LAKESHORE PARK BUILDING JSP17-43

Consideration at the request of NSA Architects, Engineering, Planners for approval of Preliminary Site Plan and Stormwater Management Plan. The subject property is located in Section 3 west of Old Novi Road and south of South Lake Drive and is zoned R-4, One Family Residential. The applicant is proposing an update to Lakeshore Park in the City of Novi including an approximately 9,400 square foot community center, 129 parking spaces, one pavilion, and a bike lane to connect to the mountain biking trails.

MOTION SHEET

DRAWING NUMBER:
L-1.0

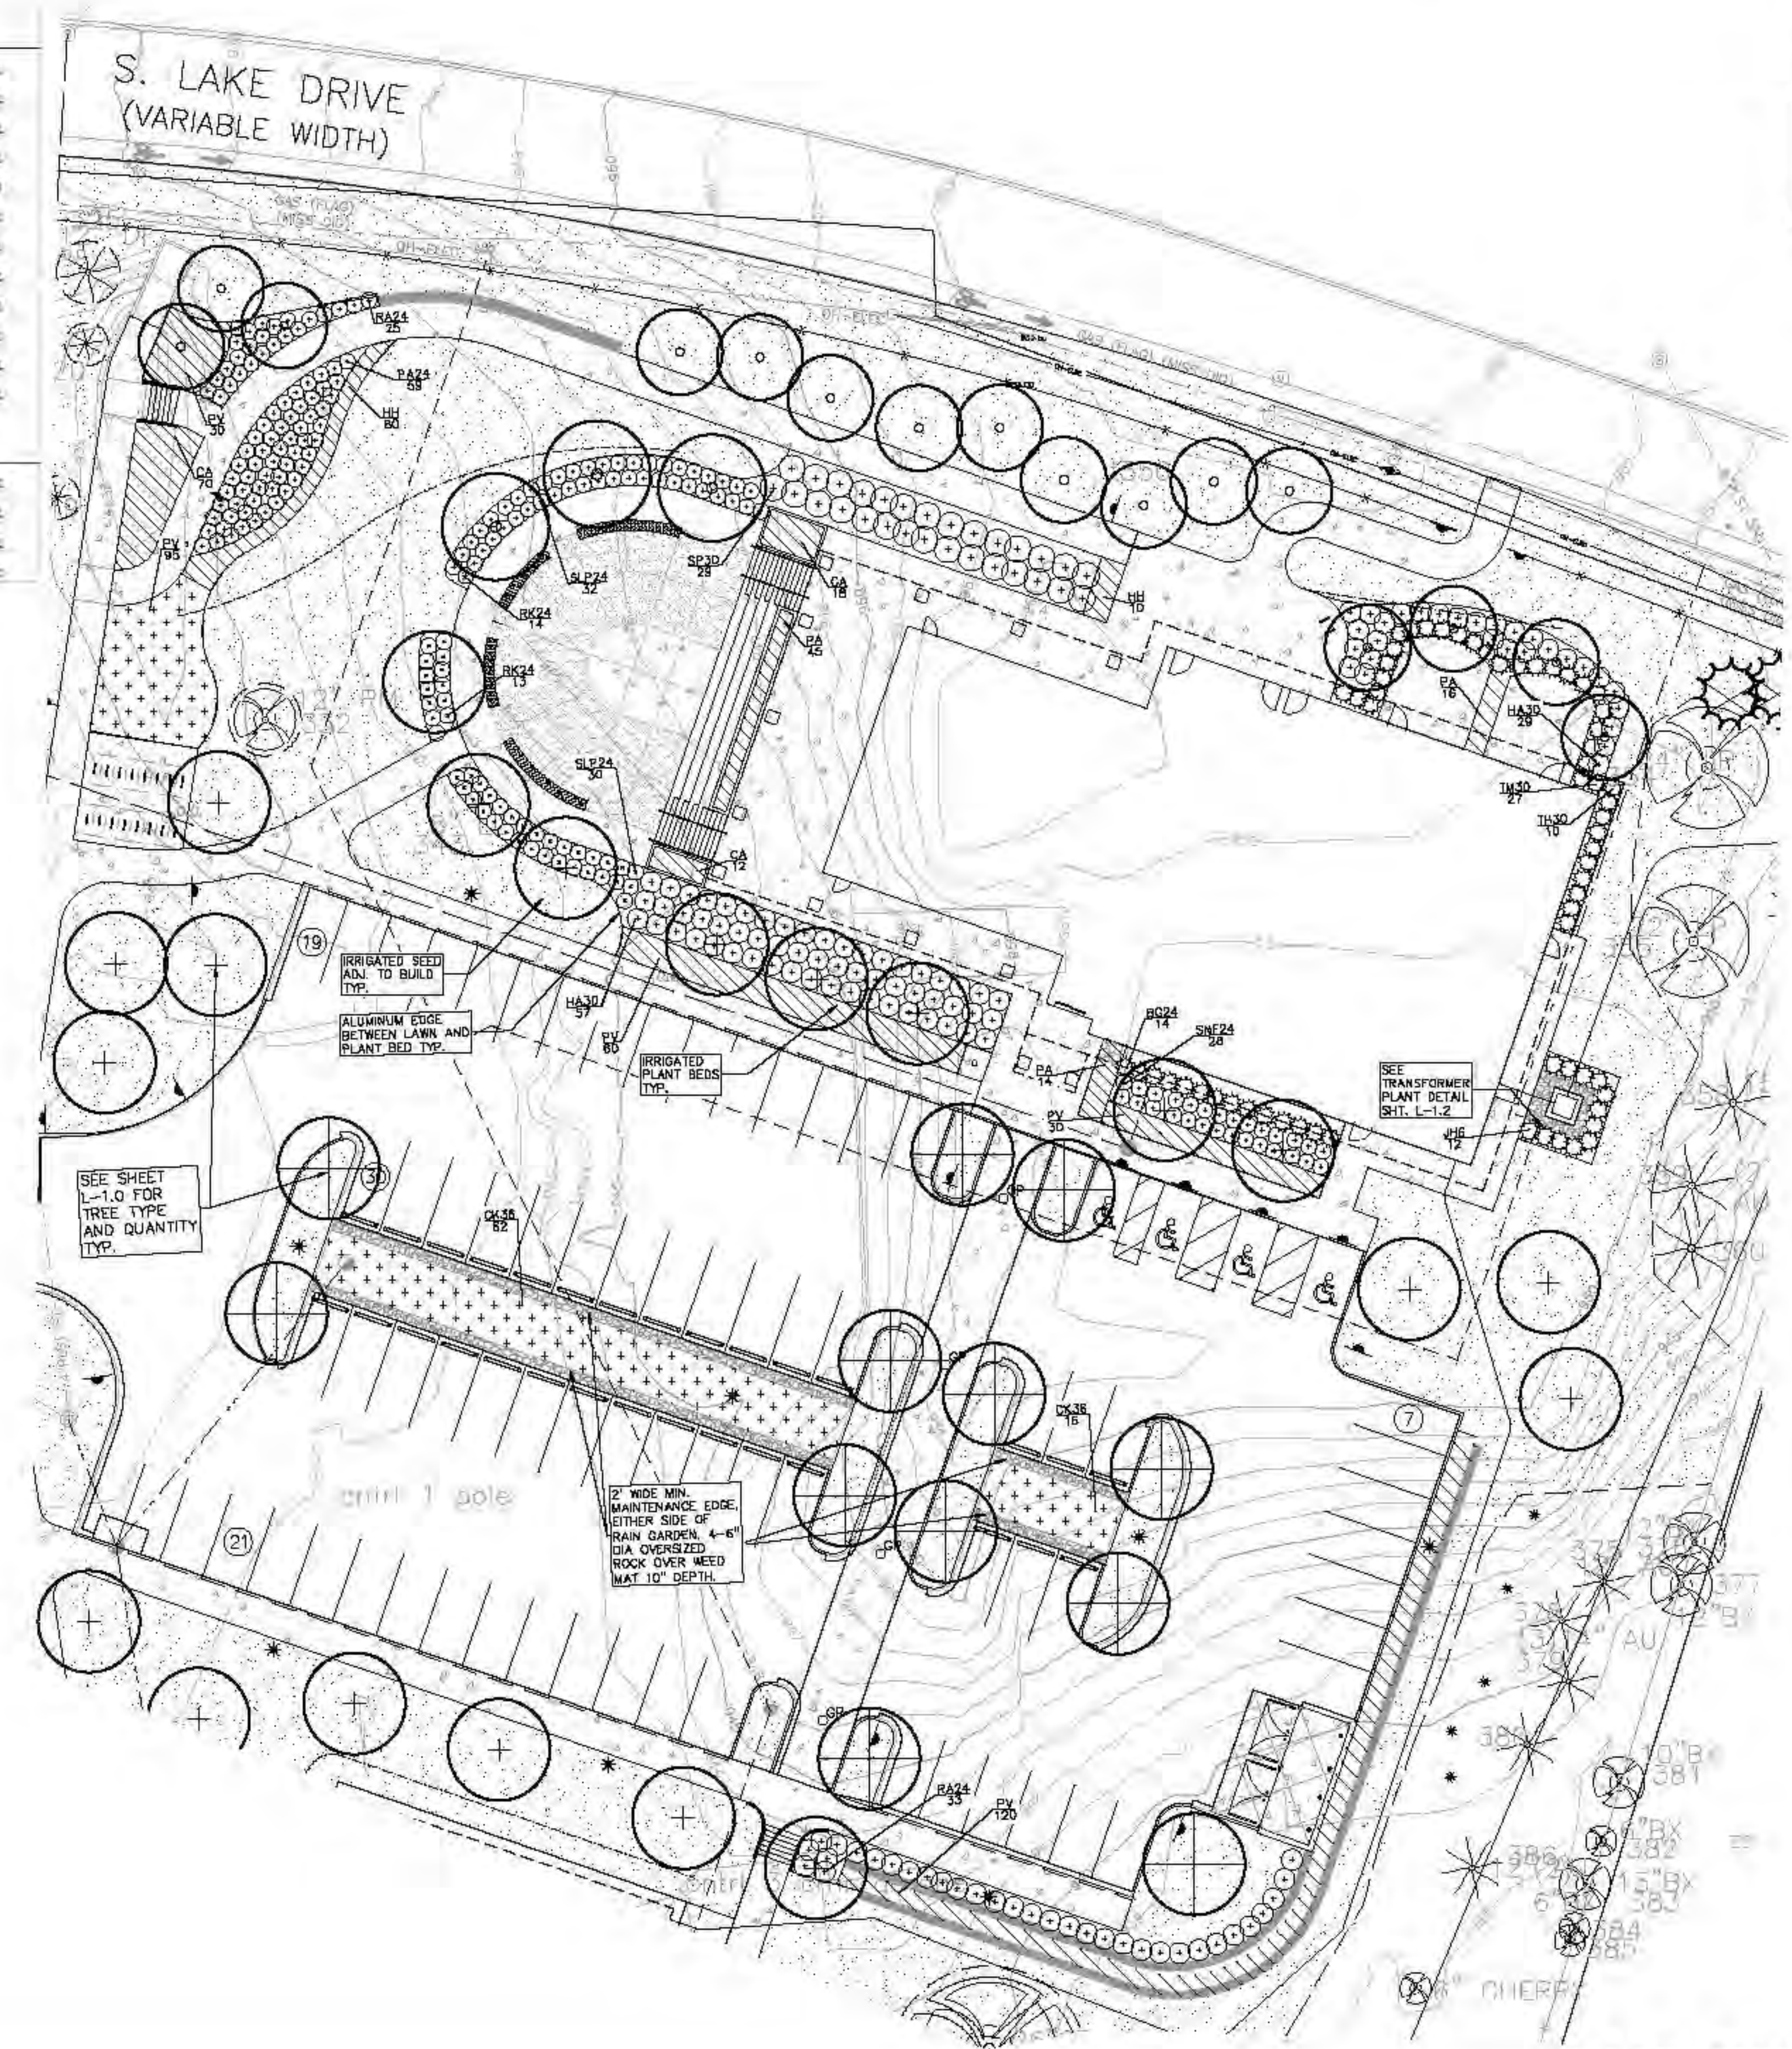
1. Please screen the transformer box per the detail on Sheet L-1.2.

Response: Foundation shrubs will be adjusted to be at least 50% native. Changes will be shown on sheet L-1.1.

Response: Irrigation system will be addressed for shrubs and sod adjacent to building, the remaining areas are non-irrigated. Changes will be shown on sheet L-1.1.

Response: The transformer will be screened per city detail on sheet L-1.1.
